ADDENDUM #2

GERP RESTROOM AND STORAGE BUILDING

BID #14/15-001 – PWP# WA-2014-224

This addendum is to notify all potential proposers of clarifications made to the Bid documents as stated below.

1 Enlarged Women's Restroom Plan Clarification

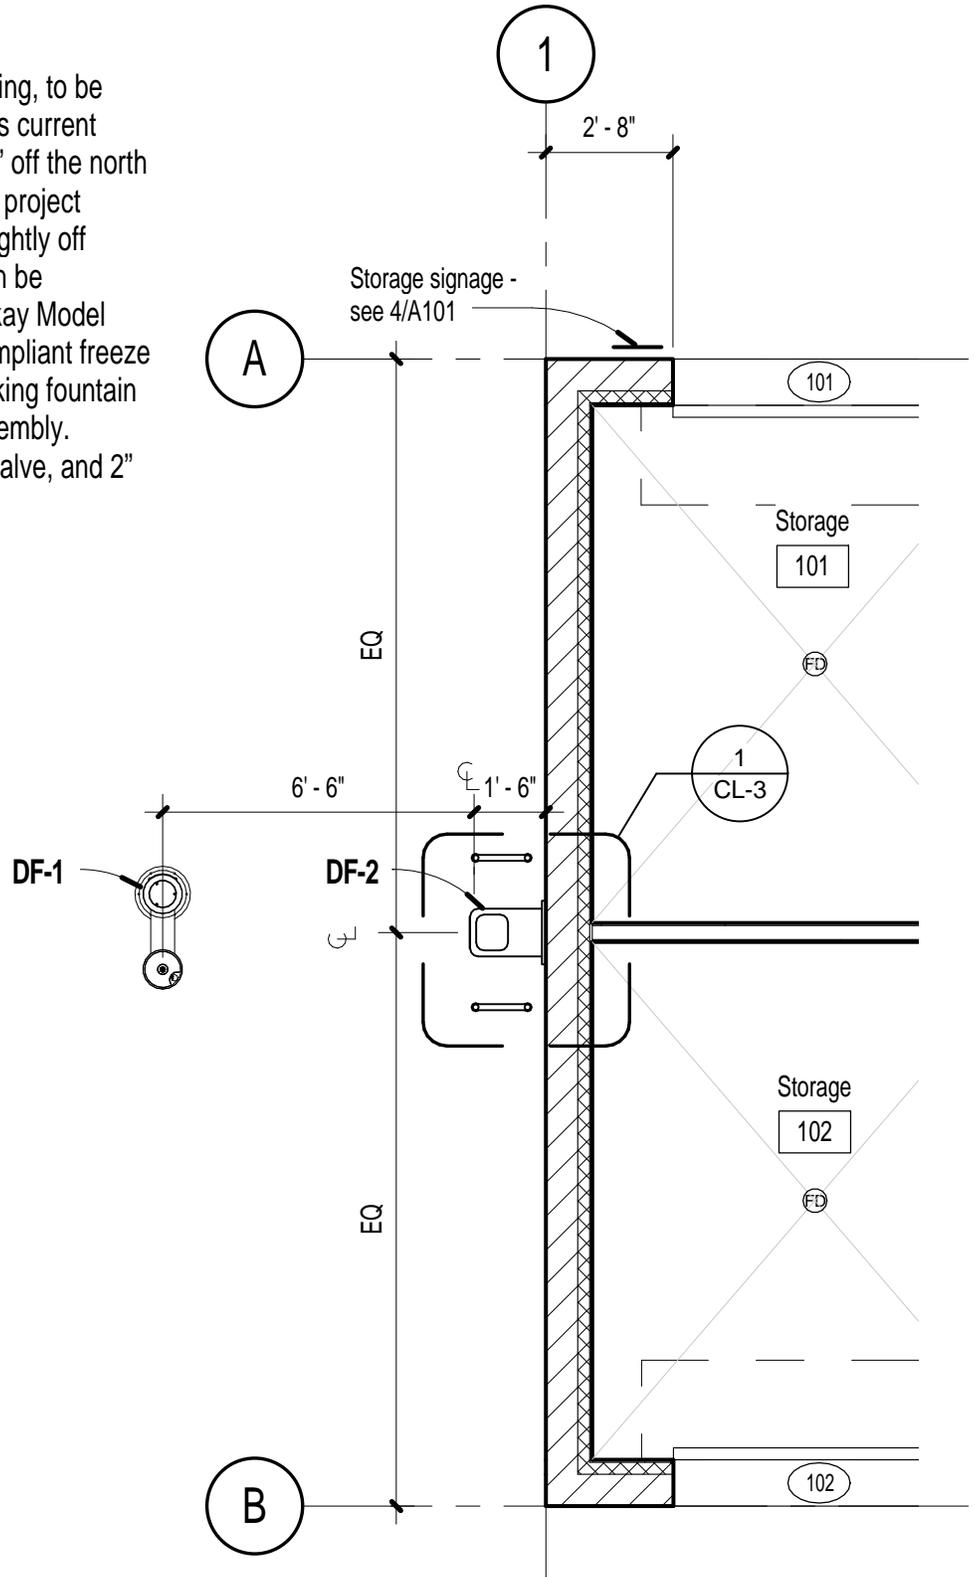
A101	Detail 2 – Enlarged Restroom Plan – Mirror at Sinks: Contractor shall provide a mirror with stainless steel angle frame per the “Toilet Accessories Schedule” – Keynote K at Women’s Room 105 as clouded. See attached drawing CL-1 and 7/A701.
A101	Detail 1 – Floor Plan – Decorative Metal Fence Components at Exterior Condenser: Contractor shall provide a metal fence with the following components: <ul style="list-style-type: none">• Corner posts - HSS3x3 1/8 galv.• Rails - HSS2x2x12ga. galv.• Pickets – R 1/8x1 galv.
A101	Detail 1 – Floor Plan – Additional water fountain added per 2012 IBC: Contractor shall provide an additional standard freeze resistant drinking fountain and relocate the combination Elkay water filling station/drinking fountain per attached clarification drawing CL-2 and DF-2.

1 Water Fountain Station

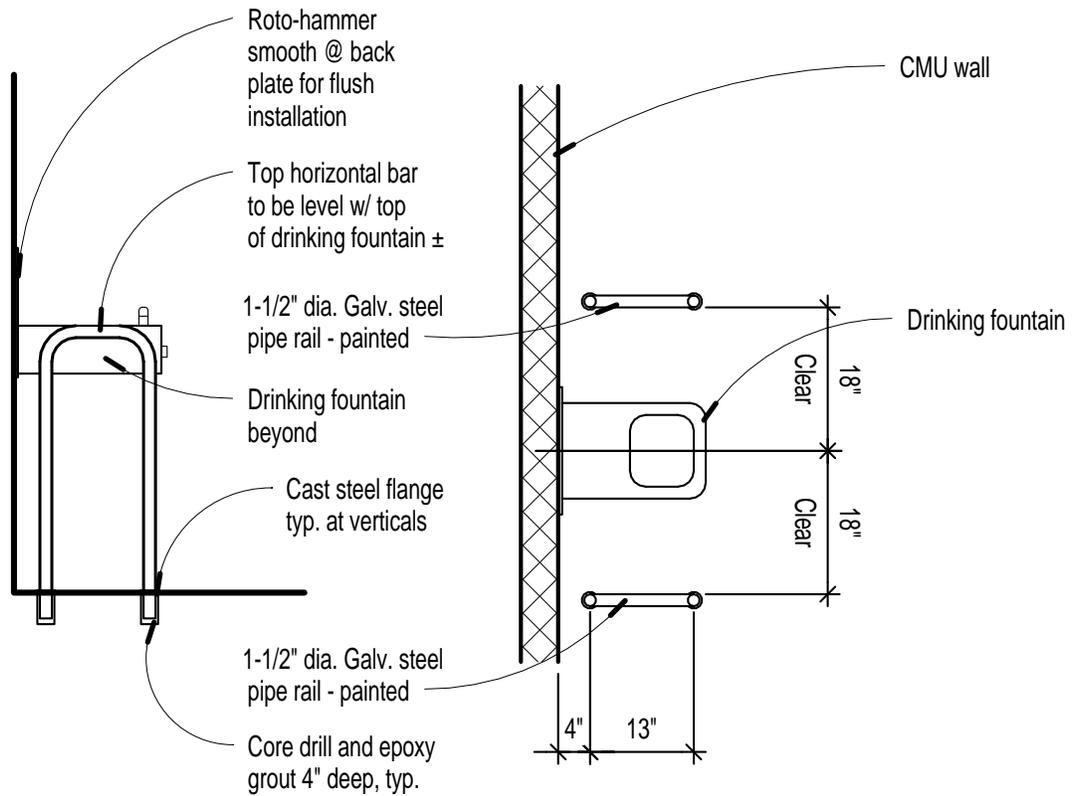
DF-1, including waste, vent and water piping, to be relocated approximately 6'-6" west from its current location (for a position approximately 8'-0" off the north wall of the building). DF-2 to be added to project scope on the north wall of the building, slightly off center so freeze proof valve assembly can be accessed from Storage Room. DF-2: Elkay Model #ECDFPW314FP stainless steel ADA compliant freeze resistant vandal-resistant wall mount drinking fountain with wall plate and freeze proof valve assembly. Provide 1/2" CW branch line with shut-off valve, and 2" waste and vent branch lines as required.

1 Drinking Fountain Barrier

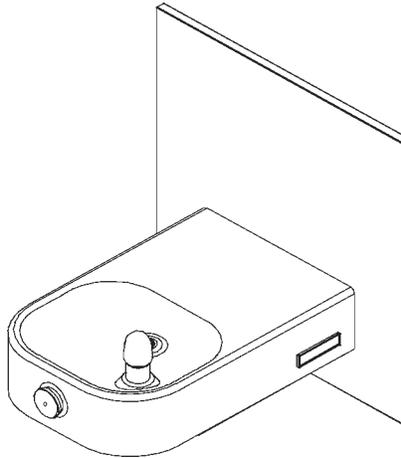
1. See Accessible Drinking Fountain detail for requirements at drinking fountain.
2. Cast steel flanges shall be welded to pipe verticals after pipe is install. Prep welds for paint.
3. Pipe rail and flanges shall be painted.
